SUBJECT: ST. LUCIE UNIT 1 - ISSUANCE OF AMENDMENT RE: BORIC ACID MAKEUP TANK
MINIMUM INVENTORY REQUIREMENTS (TAC NO. M88976)

Amendment No. 129
License No. DPR-67

SAFETY EVALUATION BY THE OFFICE OF NUCLEAR REACTOR REGULATION

**FIGURE 3.1-1 ST. LUCIE 1 MIN BAMT VOLUME
VS STORED BAMT CONCENTRATION**

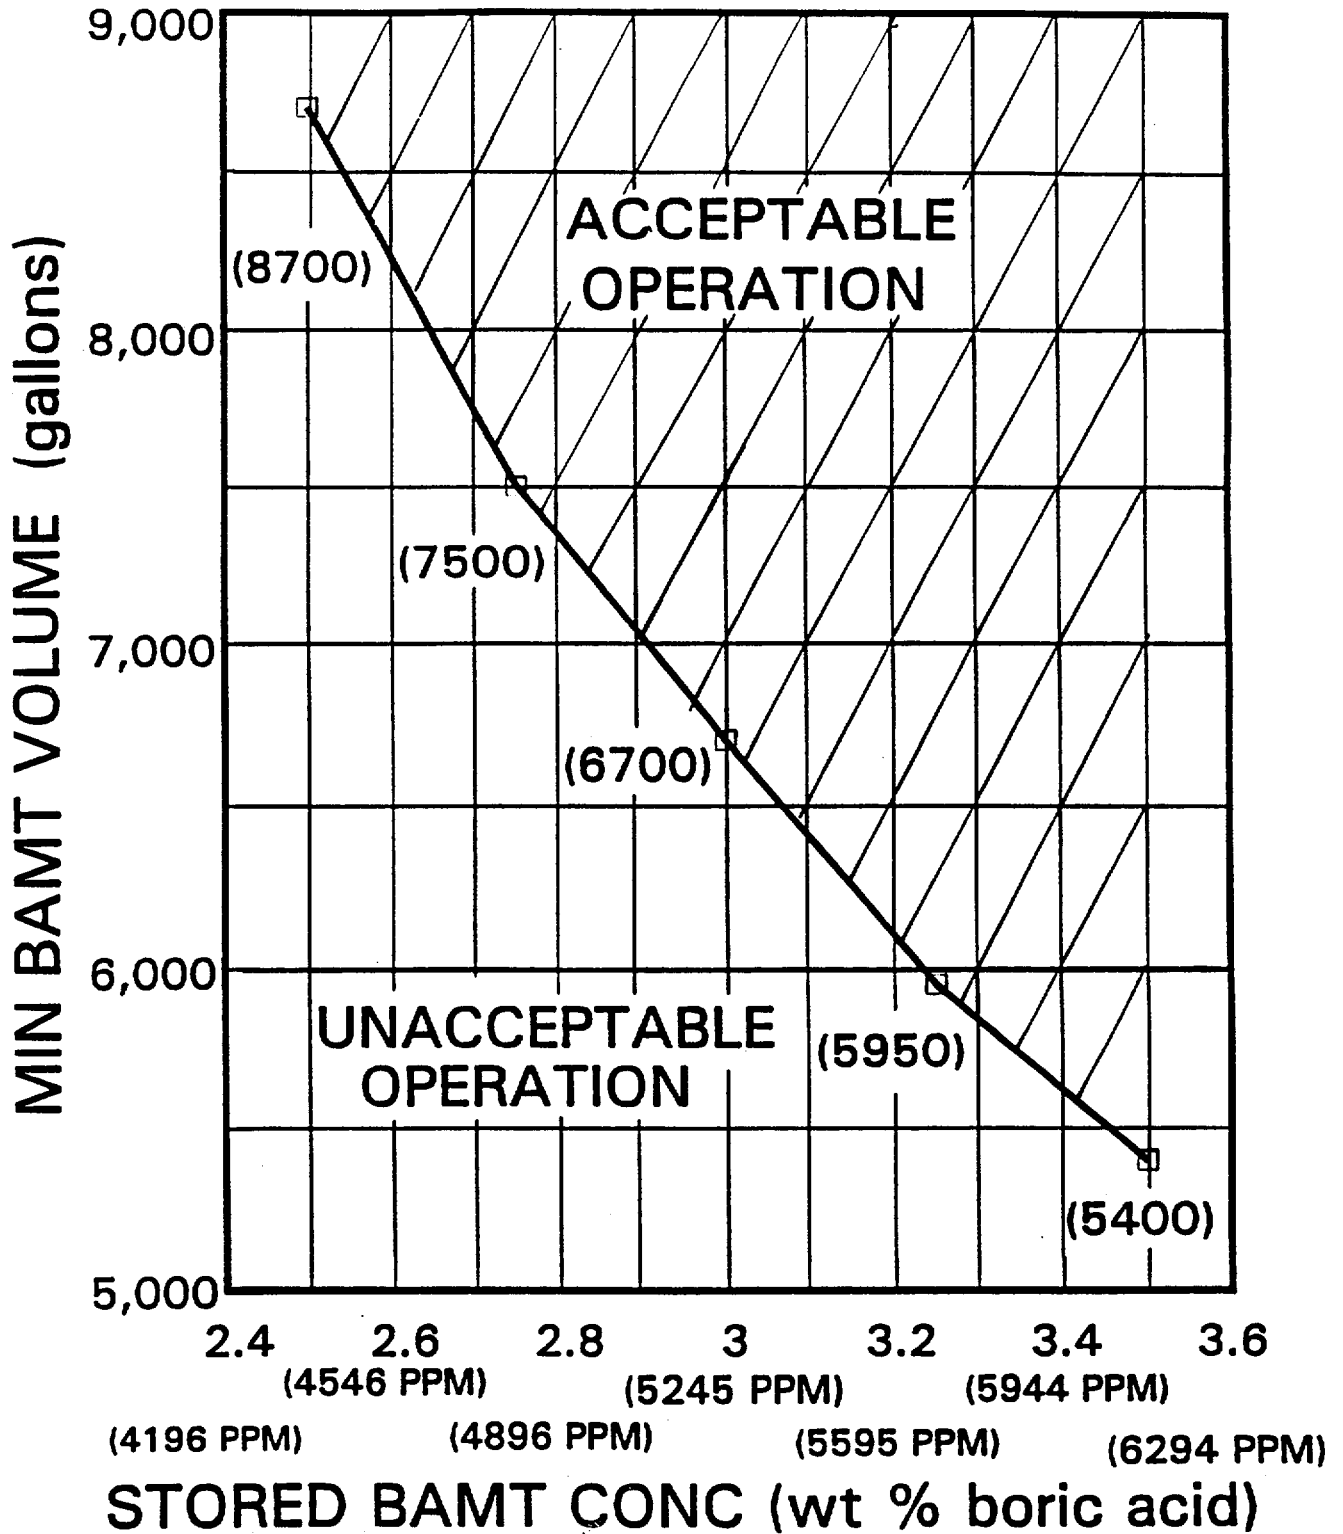
This amendment modifies the minimum stored borated water inventory requirements for Operational Modes 1 through 4 by revising Figure 3.1-1 and Limiting Condition for Operation 3.1.2.8 of the unit Technical Specifications (TS). The associated bases for TS 3/4.1.2 are also revised to reflect the bounding borated water makeup volumes, as a function of boric acid concentration, which define the proposed inventory requirements.

By letter dated February 22, 1994, Florida Power and Light (FPL) (the licensee) proposed changes to the Technical Specifications (TS) for the St. Lucie Unit 1 facility. Specifically, the proposed changes were a modification of (1) Figure 3.1-1, (2) the Limiting Condition for Operation (LCO) 3.1.2.8 and (3) the associated bases for TS 3/4.1.2. These changes are related to reducing the minimum stored borated water inventory requirements. It is the licensee's contention that the proposed amendment will significantly improve operational flexibility with no risk to plant safety and that it will also provide consistency in operation between the Unit 1 and Unit 2 plants.

The licensee stated that the proposed BAMT inventory reduction is made possible by increasing the make-up water provided by the RWT during plant cooldown. The boration requirements were determined by the licensee using conservative assumptions in order to maximize the boron demand. It was also assumed that the approved boric acid concentration of 2.5 - 3.5 percent by weight (wt%) in the BAMT remained the same. The licensee concluded that additional demand on the RWT inventory has no impact on the existing TS RWT minimum volumes and boron concentration.

In the currently documented volume reduction analysis, CEN-353(F), Revision 3, 1000 gallons of borated water was added to the calculated BAMT volume to provide additional volume for auxiliary spray while depressurizing the RCS. The additional volume is required because the analysis assumes that motor-operated valve V2504 fails to automatically open. In Supplement 1 to CEN-353(F), Revision 3, the volume reduction analysis for these proposed changes, the final volume is determined by (1) adding a 500-gallon allowance for conservatism and (2) removing the additional 1000-gallon allowance for auxiliary spray from the BAMTs. The licensee justifies this reduction by taking credit for manual handwheel operation of V2504. These BAMT volume adjustments are consistent with the volume adjustments made for St. Lucie, Unit 2.

In the case where one BAMT is used, the maximum useable capacity is 9450 gallons and TSs 3.1.2.8.a and b currently specify a minimum boric acid concentration of 3.2 wt% for an individual BAMT. Figure 3.1-1 is actually based on the use of two BAMTs. This results in limiting the range of permissible inventories for the selected tank to the narrow operating band delineated in Figure 3.1-1 of the current TSs.

By reducing the inventory to the single BAMT range of 5,400 - 8,700 gallons, the corresponding boric acid concentration is 3.5 - 2.5 wt%, respectively. Therefore the 3.2 wt% minimum for the boric acid concentration for an individual BAMT is not required.

The licensee has proposed to modify Figure 3.1-1 and TS 3.1.2.8 so that the requirements will be applicable to an individual BAMT. These changes are supported by the analytical results of CEN-353(F) Supplement 1 which includes previously approved methodologies, worst-case assumptions, and allowances for the uncertainties.

The licensee indicated that the revised BAMT and RWT inventories will continue to provide assurance that the safe shutdown margins specified in the TS can be met for the most limiting accident conditions during core fuel cycles. Based on these elements the staff finds the proposed BAMT inventory requirements acceptable.
